Solar Lights Lite Rev C: module geometry (board regenerated with these values)

Compare each drawing with the real module. GREEN = given by you / vendor drawing. AMBER = assumed or read off a drawing. RED = I need your answer.

1 TP4056 charger module

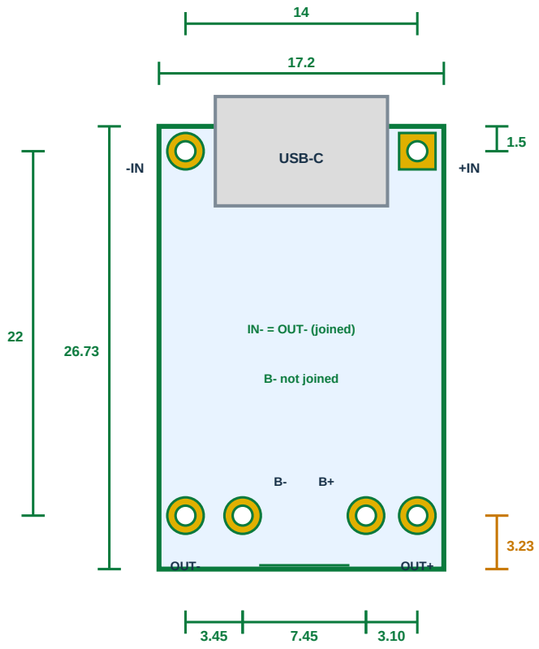
Your markup: length 26.73 (not 28), rows 22 apart (not 23), IN row 1.5, bottom 3.0.

7.7 mm = gap between the B- and B+ hole edges -> hole about 1.2 mm?

Copper pad size not given: 2.2 mm assumed (carrier side is unaffected).

CHECK A Is your 7.7 mm the gap between the B- and B+ hole edges (so hole = 1.2 mm)?

pad	u(from USB end)	v(from +side edge)	carrier x,y
+IN	1.5	1.60	68.60, 2.50
-IN	1.5	15.60	54.60, 2.50
OUT+	23.5	1.60	68.60, 24.50
B+	23.5	4.70	65.50, 24.50
B-	23.5	12.15	58.05, 24.50
OUT-	23.5	15.60	54.60, 24.50

2 Pro Mini (BTE13-010A clone)

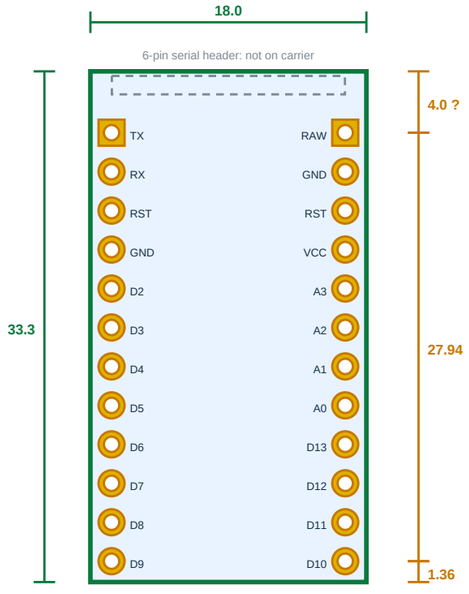
33.3 x 18.0, 27.94 span (2.54 pitch): ticked. Pin 1 at 4.0 from the serial end.

Photo of the real board gives 4.0 / 1.36 (sums to 33.3); 3.4 / 2.5 did not. Please re-check.

Row spacing 15.24 ticked. Template must be printed at exactly 100%.

CHECK B Pro Mini pin 1 at 4.0 / far end 1.36 (from your photo, +/-0.3): please confirm with calipers.

3 Wemos D1 Mini

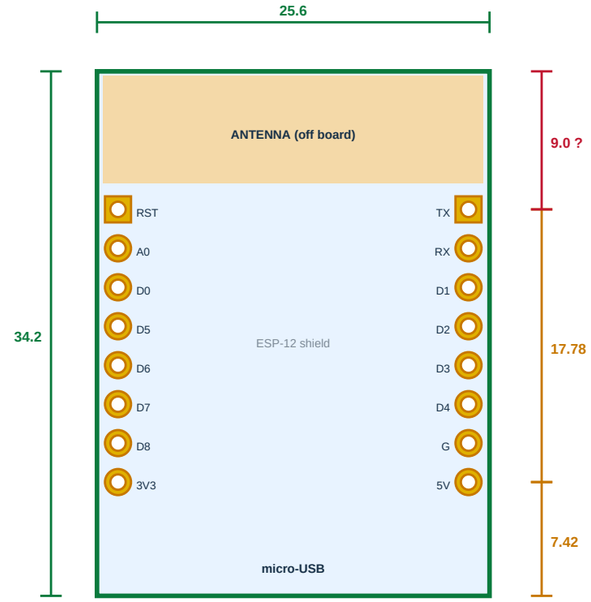
34.2 x 25.6: given. Row spacing 22.86 (0.9 in) is standard: assumed.

Pin 1 (RST, square) centre to antenna-end edge: please measure.

OPEN 3 D1 Mini: pin 1 (RST) centre to antenna-end edge (9.0 assumed). Not on your sheet.

4 Board 74 x 51.5 mm with the new module sizes

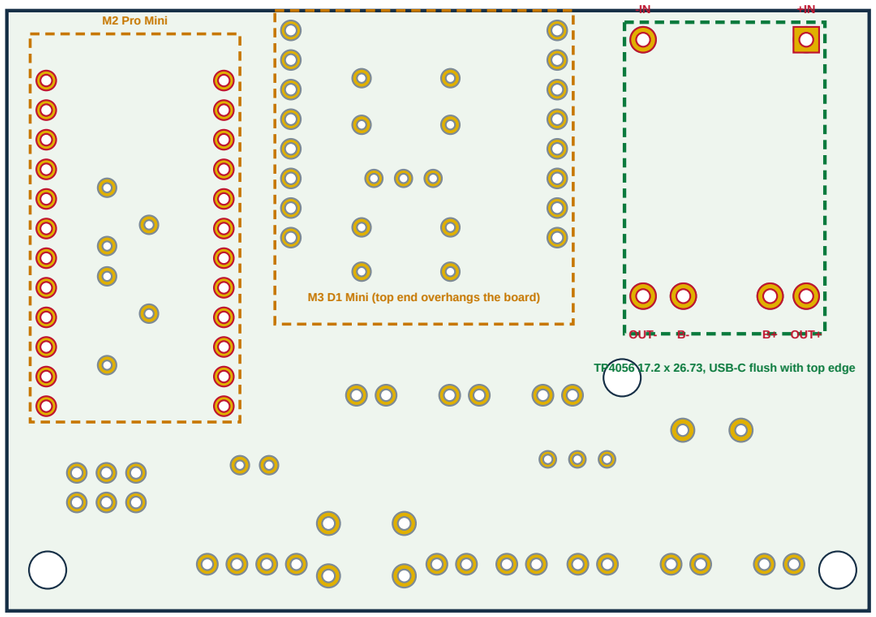
Dashed = module bodies. Red = new TP4056 and Pro Mini holes. Grey = other holes on the current board.

OPEN 4 Socket height (8.5 mm assumed); parts under modules need about 6 mm clear.

On regenerate: Pro Mini pins move down 2.0 mm (pin 1 y 6.0); TP4056 body ends at y 27.7; silk shifts.
